***REVISION***  
**MONTGOMERY COUNTY HISTORIC PRESERVATION COMMISSION**  
**STAFF REPORT**

<b>Address:</b>	7310 Baltimore Ave.	<b>Meeting Date:</b>	5/10/17
<b>Applicant:</b>	Brian McCarthy	<b>Report Date:</b>	5/3/17
<b>Resource:</b>	Contributing Resource Takoma Park Historic District	<b>Public Notice:</b>	4/26/17
<b>Review:</b>	HAWP	<b>Tax Credit:</b>	n/a
<b>Case Number:</b>	37/03-16CCC	<b>Staff:</b>	Dan Bruechert

**Proposal:** Remove a historic window at the rear of a side elevation and install a replacement.

Figure 1: The proposals is to replace the circled window.

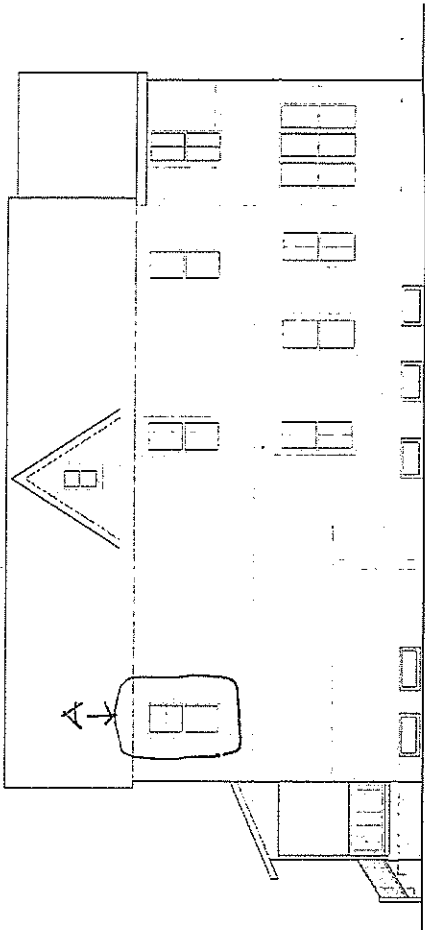
The applicants propose to remove the 2<sup>nd</sup> story two-over-two sash window at the rear of the left elevation and replace it with a two-over-one sash window that matches the approved windows for the rehabilitated sleeping porch. The applicant proposes this change in the hope of creating a cohesive interior appearance from the reconfigured master bedroom.

While the loss of a historic wood window is discouraged, Staff believes that this change will not significantly impact the historic house or the surrounding district and does comport with the Takoma Park Historic District Design Guidelines. Specifically, the Design Guidelines stress that changes to Contributing Resources should be “evaluated based on their impact to the overall streetscape and its compatibility with the existing patterns, rather focusing on a close scrutiny of architectural detailing.” This window is at the rear of a secondary elevation that is only visible when viewed from limited angles of the public right-of-way (see: Figure 1). The Design Guidelines additionally state, “Original size and shape of window and door openings should be maintained...” in this instance, the window opening size and frame will remain, the window’s sashes will be replaced.

Along the left elevation, the existing windows are a mix of six-over-six and two-over-two sash windows. Because of the existing incongruous appearance, the proposed change will not change what would otherwise be a cohesive appearance along the elevation. The proposed window replacement will, however, maintain the existing fenestration pattern. While Staff does not encourage the removal and replacement of historic wood windows except when they have degraded beyond repair, in this limited instance, for the reasons stated above, Staff supports this proposal.

Staff recommends that the Commission **approve** the HAWP application as being consistent with Chapter 24A-8 and with the *Takoma Historic District Design Guidelines*,
